**Addendum No. 001**

**Subject:** Rhawnhurst Elementary School- Additions and Renovations  
SDP Contracts No. B-070 (R), B-071 (R), B-072 (R) and B-073 (R) of 2019/20

**Location:** Rhanwhurst Elementary School  
7809 Castor Avenue  
Philadelphia, Pennsylvania 19152

**This Addendum dated December 14, 2021, shall modify and become part of the Contract Documents for the work of this project. Any items not mentioned herein, or affected by, shall be performed strictly in accordance with the original documents, unless modified by prior addenda.**

DRAWING TITLE  
**SITE PHASING PLAN**

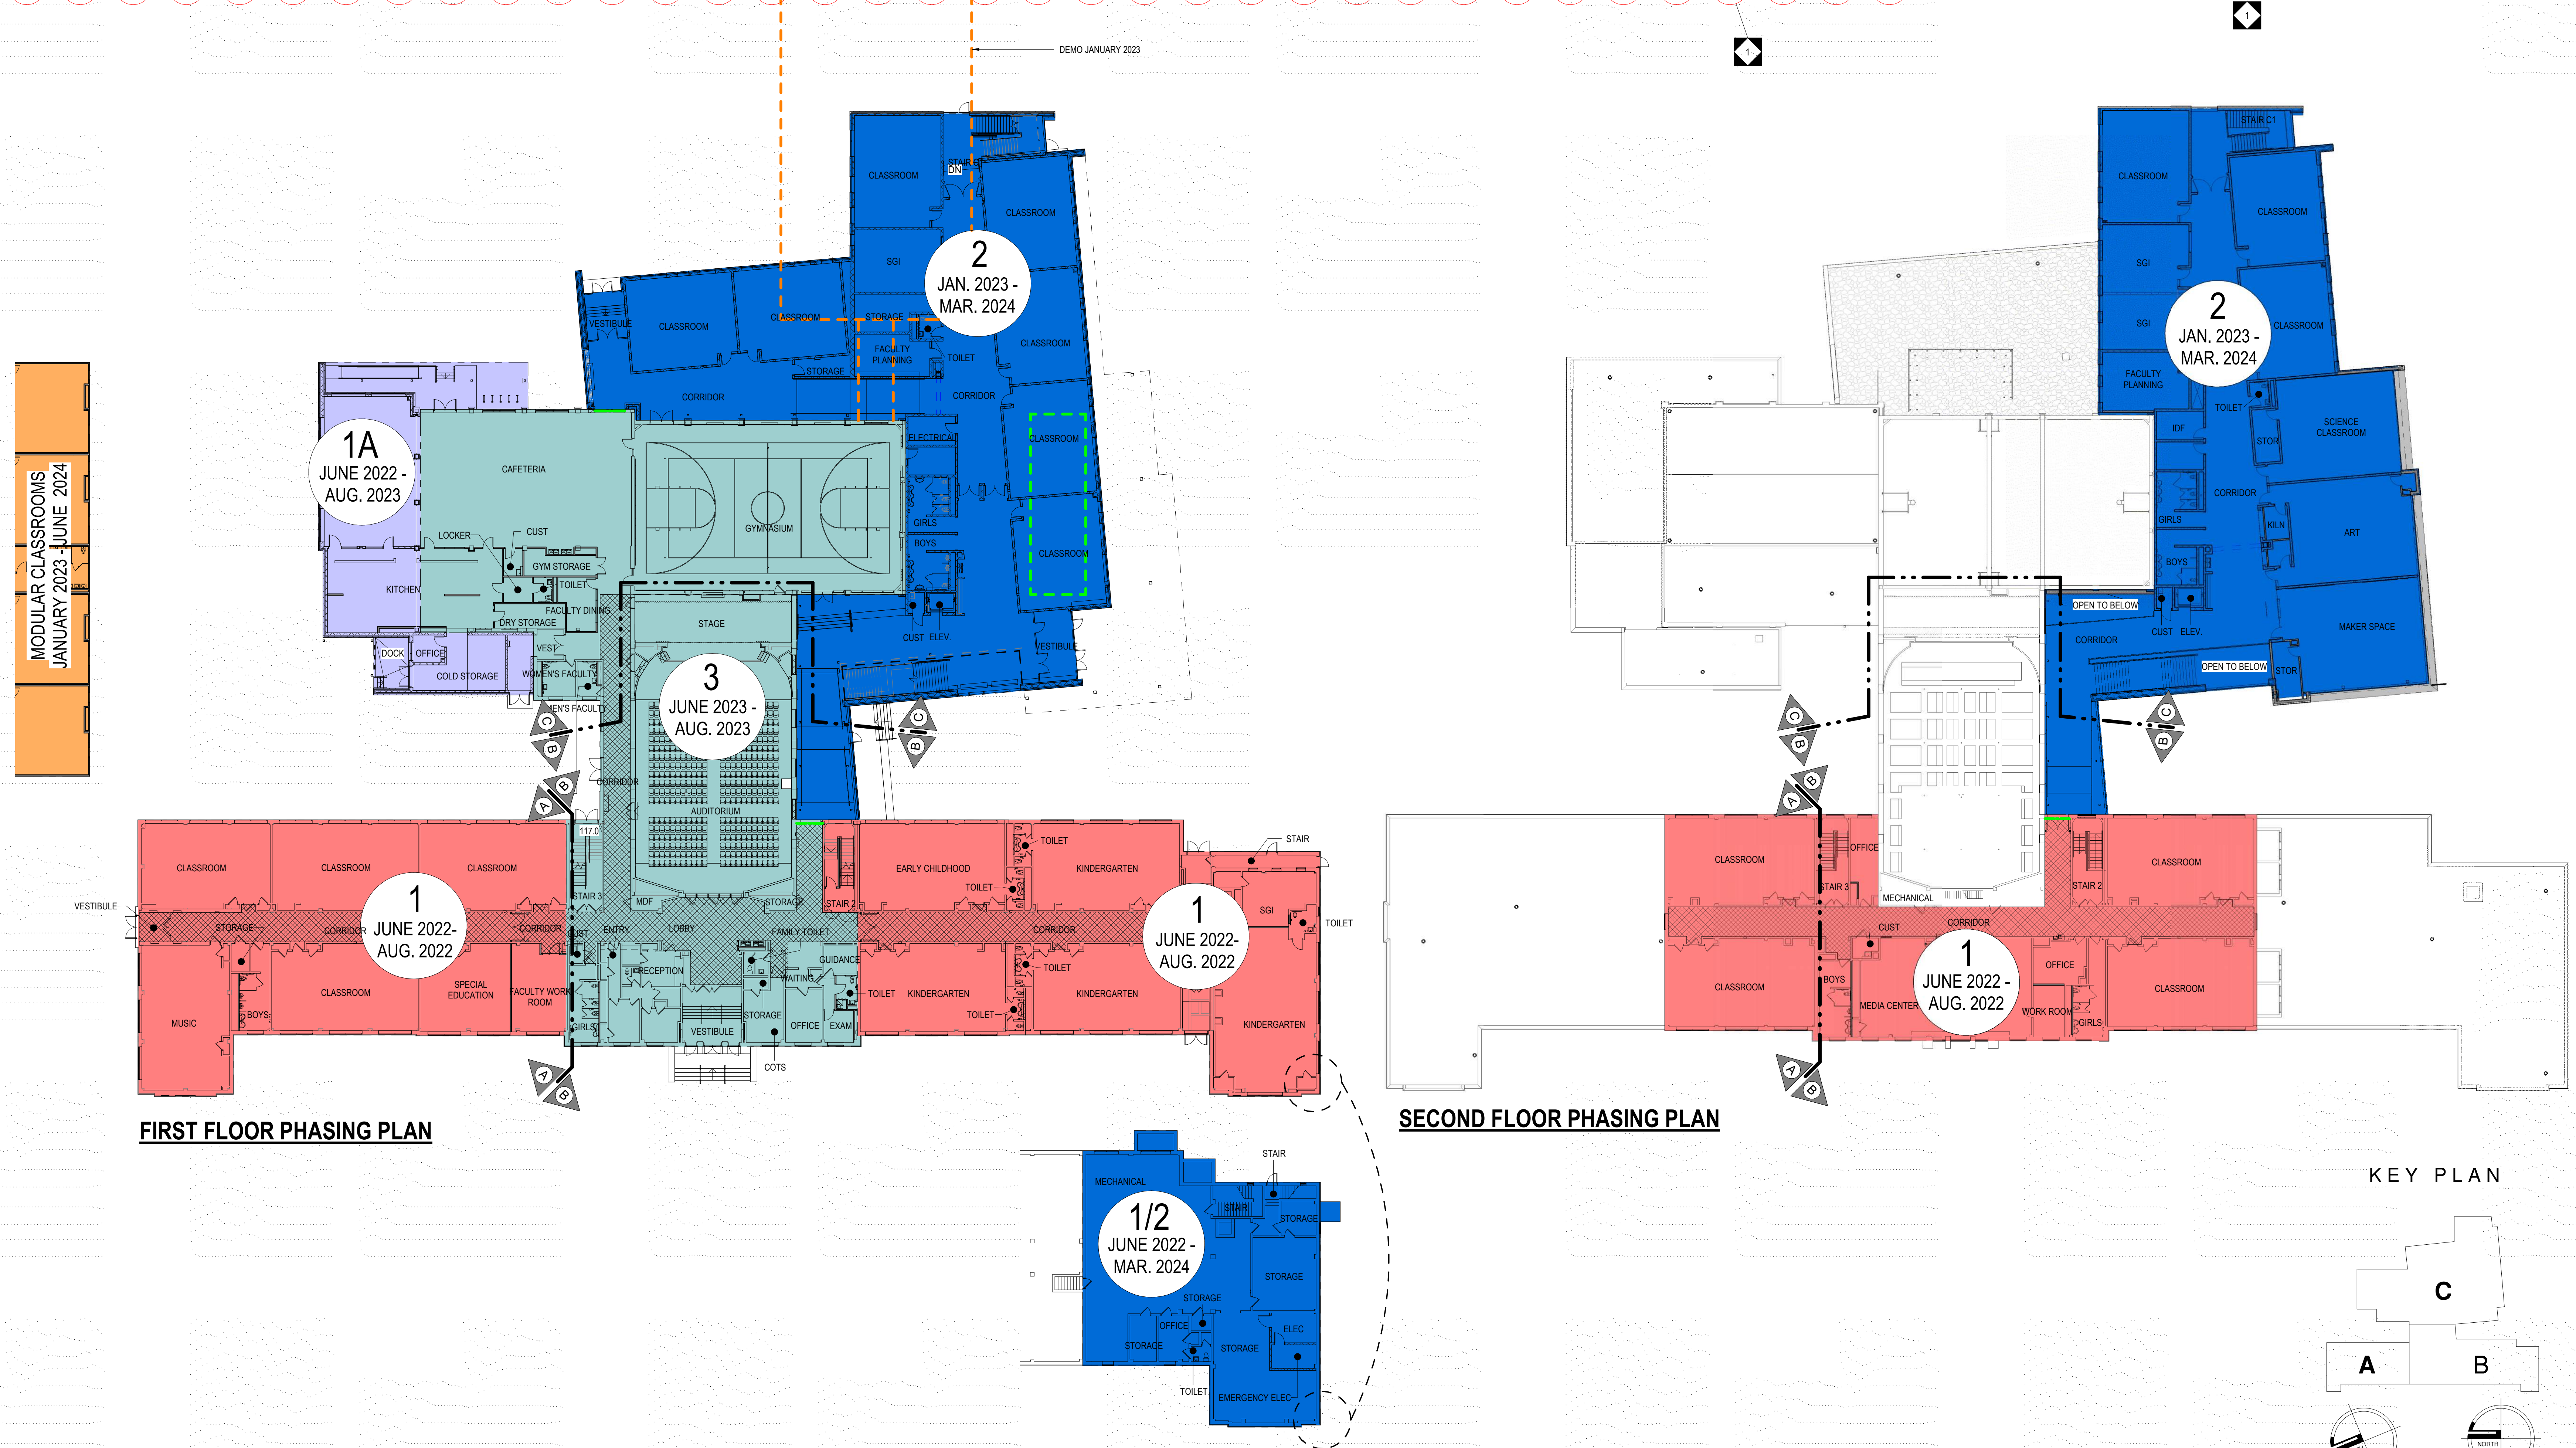
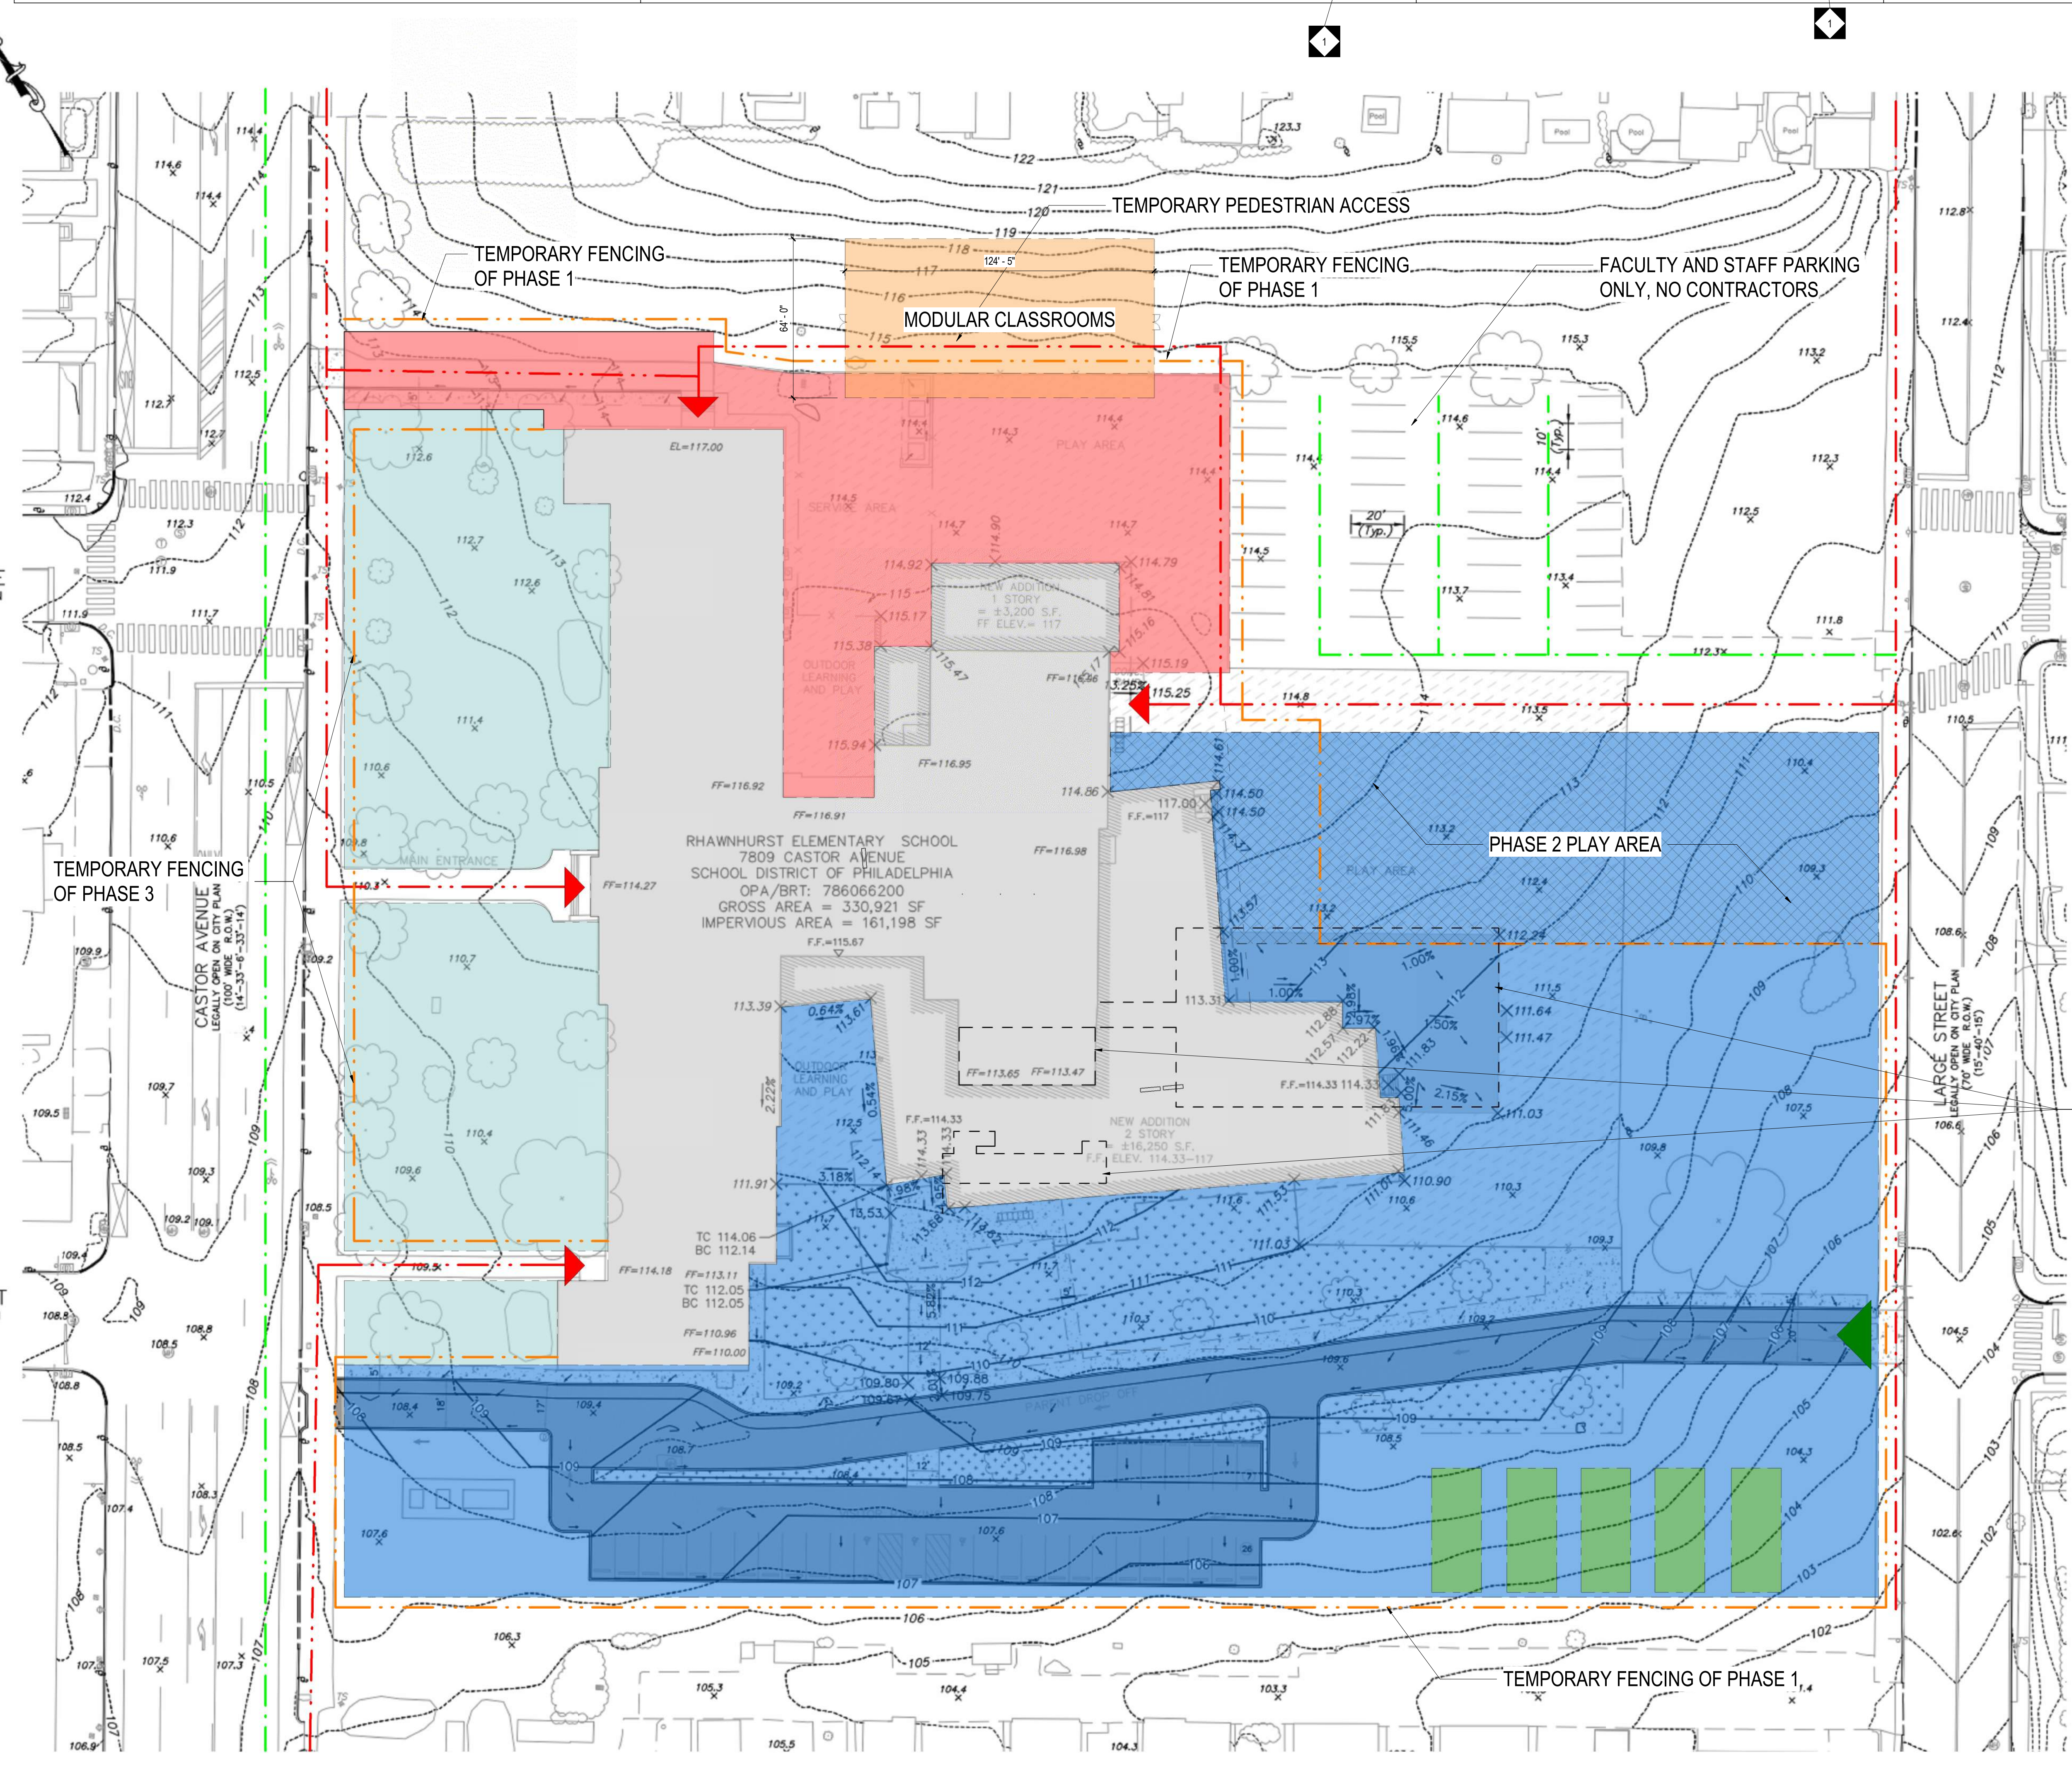
### **DRAWING PH-1 SITE PHASING PLAN**

1. **REPLACE** Drawing PH-1 in its entirety, The School District of Philadelphia (SDP) will be providing the modular classroom buildings to the construction site including foundations. Electrical contractor and plumbing contractors shall provide power and plumbing lines to modular classroom locations for The School District of Philadelphia's supplier to set foundations, classrooms and perform hook-ups to utilities. Contractors shall maintain proposed phasing schedule, if modulars classrooms and Phase 1 existing building classroom renovations are completed ahead of schedule, contractors shall work with SDP representatives for opportunity to start construction of Phase 2 new construction ahead of proposed Phasing Schedule.

**FIRST FLOOR DEMOLITION PLAN UNITS "A" & "B"**

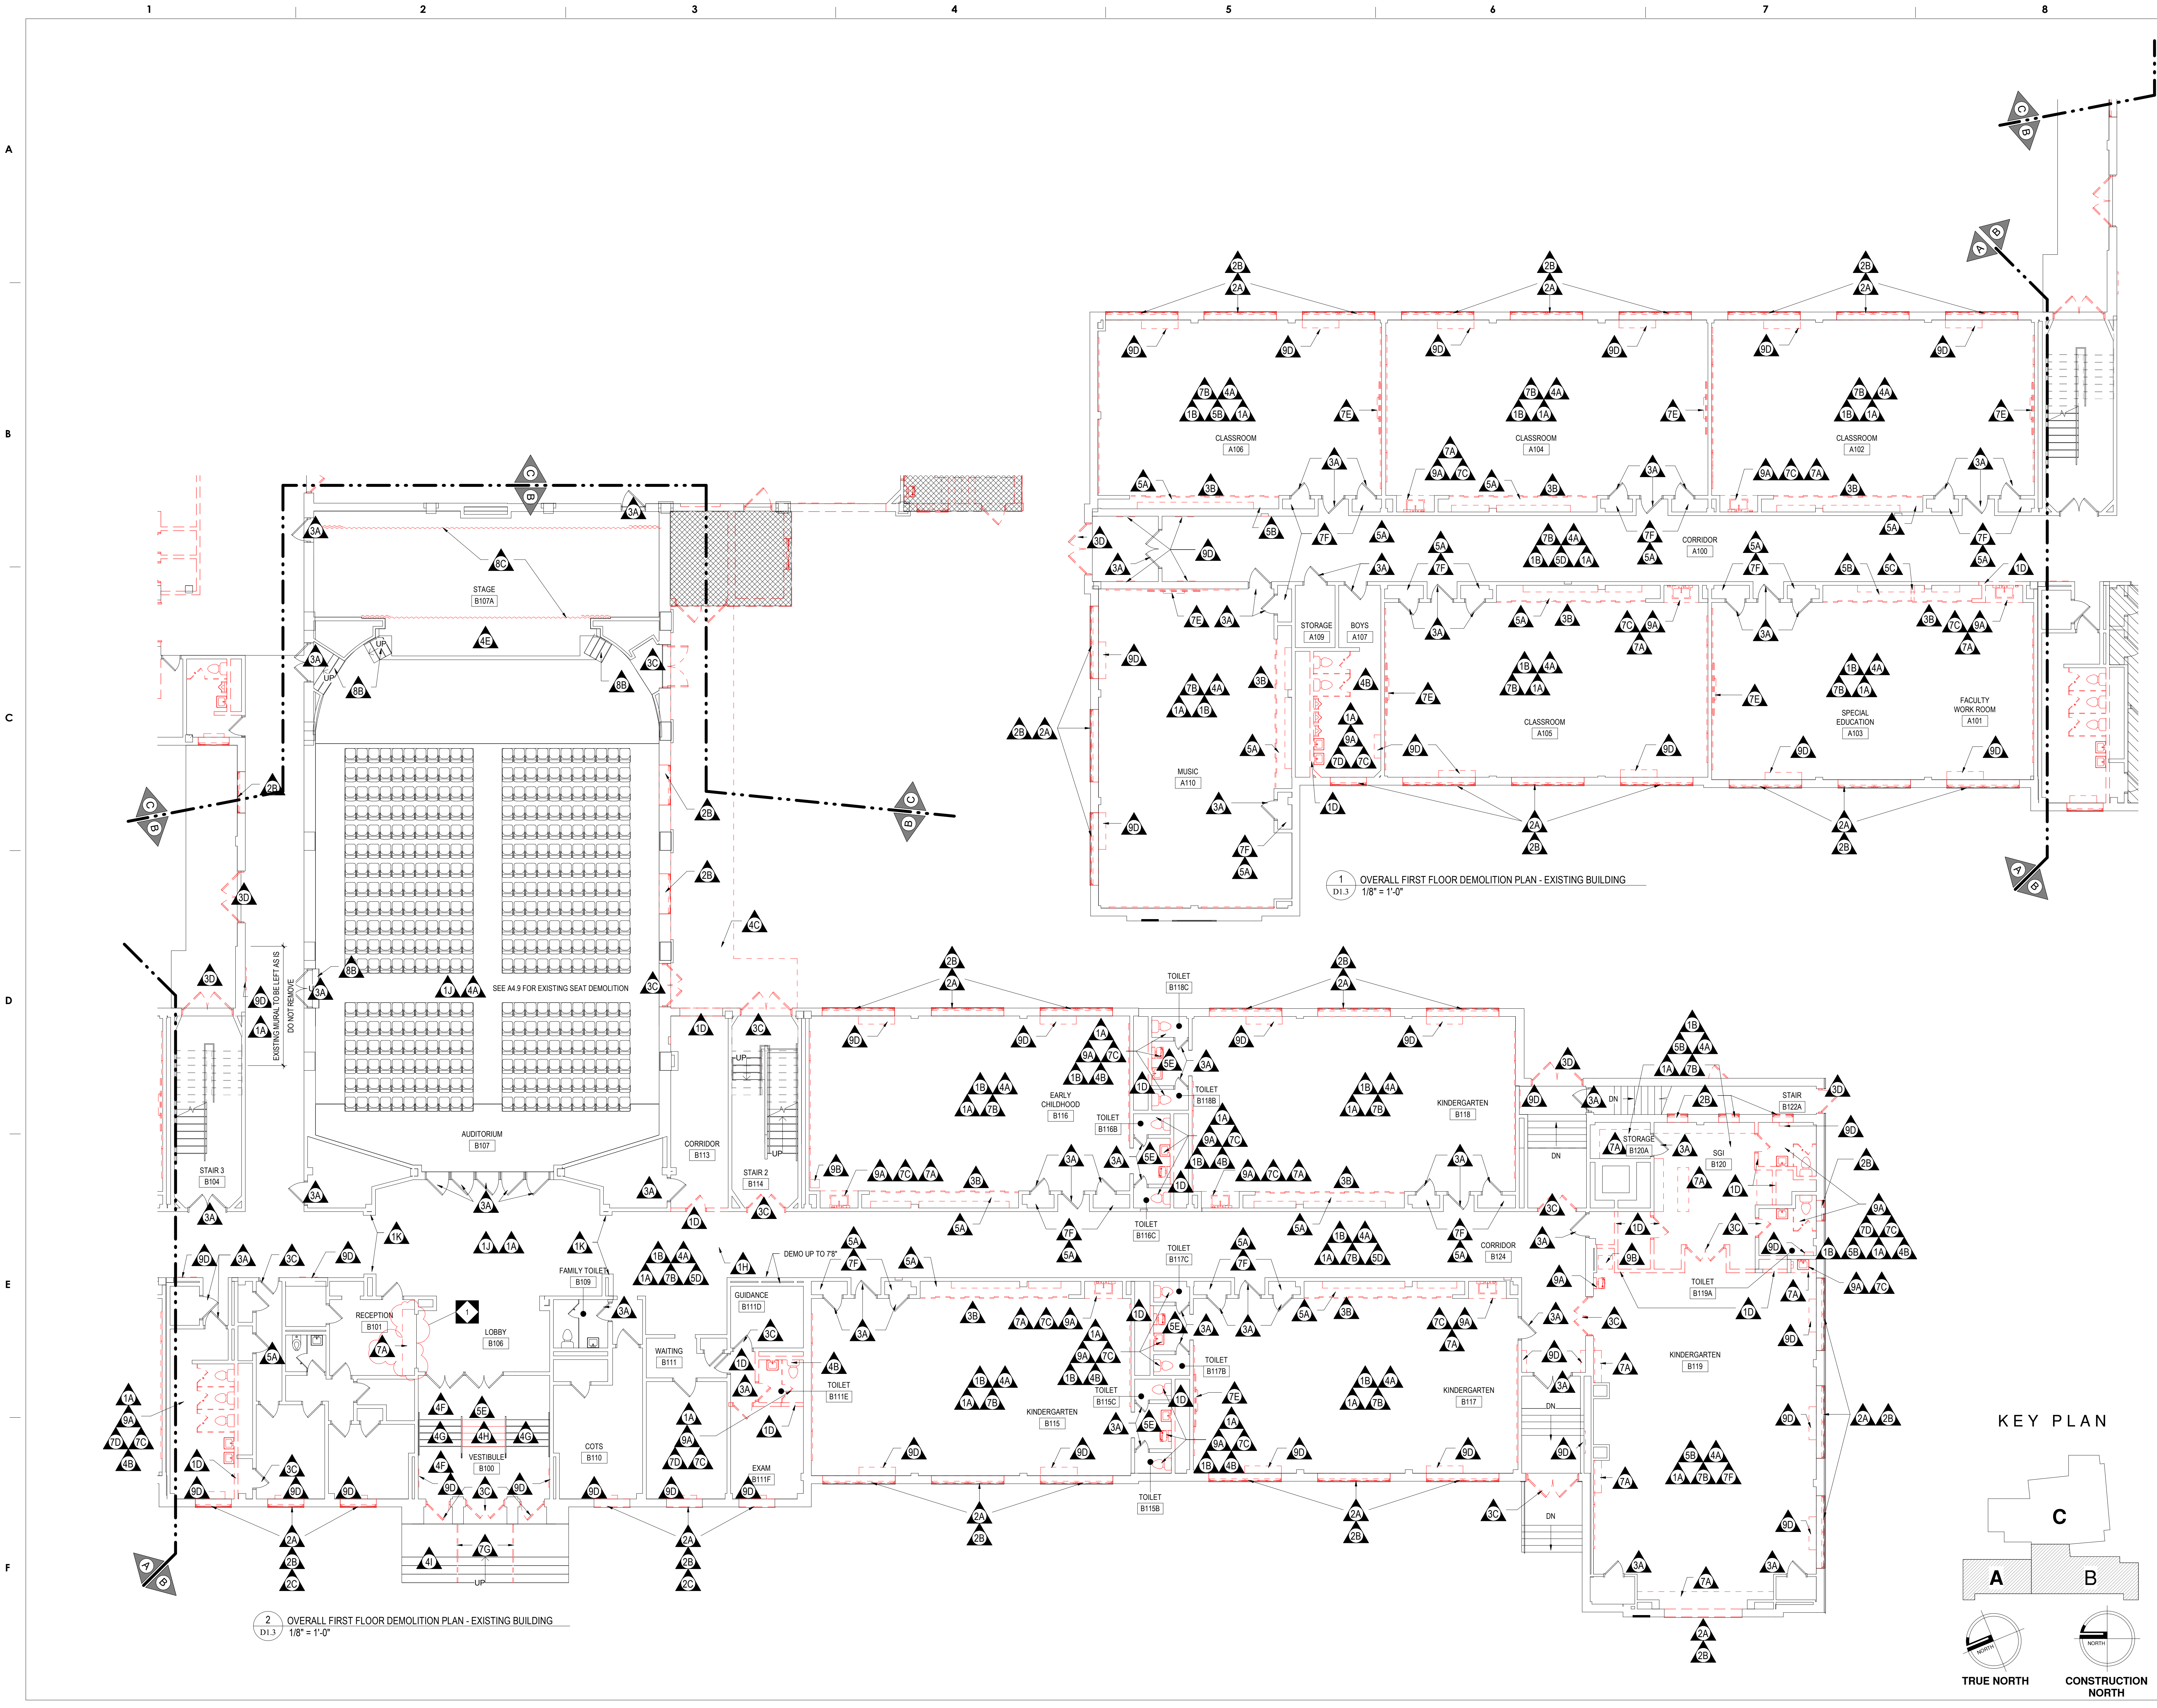
### **DRAWING D1.3 FIRST FLOOR DEMOLITION PLAN UNITS "A" & "B"**

1. **ADD** demolition note "7A - existing built-in casework and associated blocking and fasteners shall be removed in their entirety. Patch and prepare all adjacent finishes for new work and finish as scheduled" to room B101.
